**From:** Jennifer Campbell [Jennifer.Campbell@mdc.mo.gov]  
**Sent:** 12/4/2019 4:12:17 PM  
**To:** Dunn, John [Dunn.John@epa.gov]  
**CC:** Madden, Venessa [Madden.Venessa@epa.gov]; Curtis, Glenn [curtis.glenn@epa.gov]; karen\_herrington@fws.gov; Hackler, Pam [pam.hackler@dnr.mo.gov]  
**Subject:** RE: Comments on Ameren Labadie 316(a) Variance Request  
**Attachments:** MDCcomments\_Labadie316variance\_11.17.2019.pdf

**From:** Dunn, John [mailto:Dunn.John@epa.gov]  
**Sent:** Wednesday, December 04, 2019 9:41 AM  
**To:** Hackler, Pam <pam.hackler@dnr.mo.gov>  
**Cc:** Wieberg, Chris <chris.wieberg@dnr.mo.gov>; Michael Abbott - MDNR <michael.abbott@dnr.mo.gov>; heather.peters@dnr.mo.gov; karen\_herrington@fws.gov; Jennifer Campbell <Jennifer.Campbell@mdc.mo.gov>; Madden, Venessa <Madden.Venessa@epa.gov>; Curtis, Glenn <curtis.glenn@epa.gov>  
**Subject:** Comments on Ameren Labadie 316(a) Variance Request

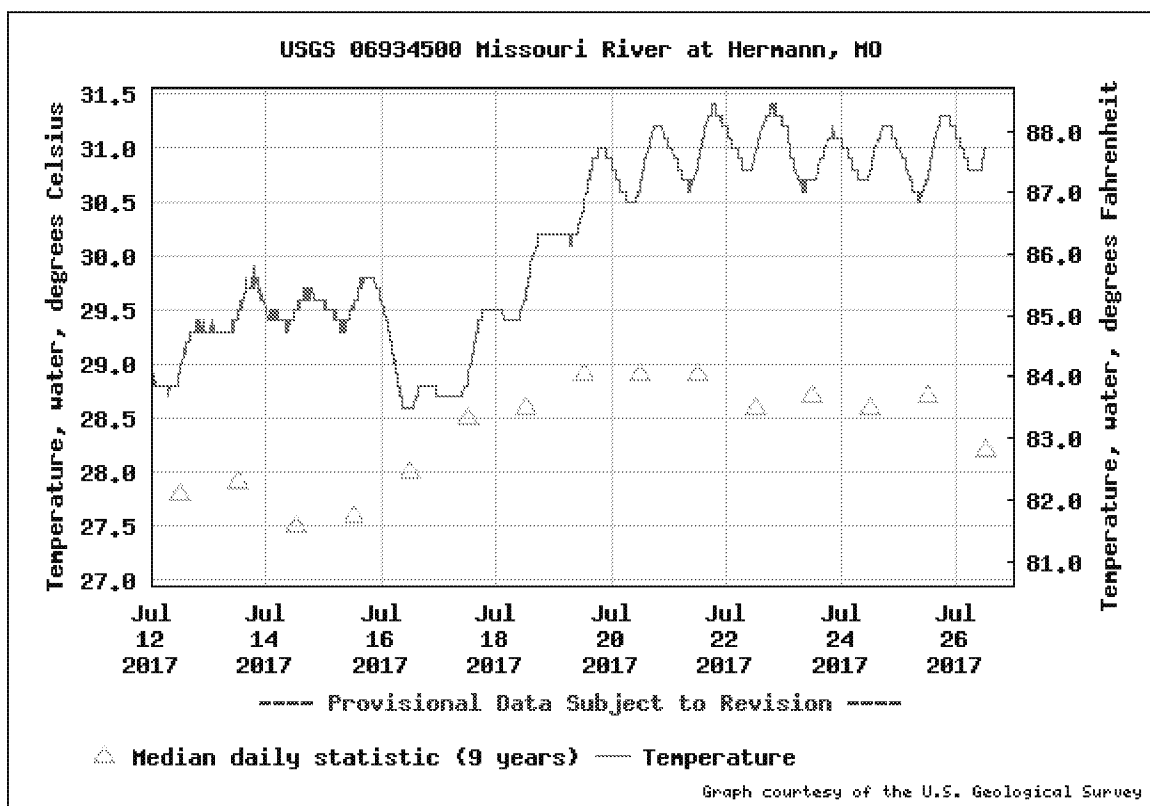
Equations for deriving TDP are calculated to many significant digits but monitoring in the current permit is only required once daily. During heat events, stream temperature can vary by up to 1.5°F in a given day. See 2017 data in the graph below.

The permit should assure that monitoring precision matches up with the detailed nature of the modeling. It should be noted that the USGS gage at Hermann, the data source for the permit, monitors Flow and Temperature every 15 minutes. Temperature can be measured inexpensively by calibrated thermistors feeding data to a computer that calculates TDP and estimated temperature at the edge of the RMZ. Continuous monitoring at this frequency would generate unneeded data, but high frequency monitoring when variance conditions are approached could create important data sets for future consideration. In any case, all data used in the model equations should be time synchronized.
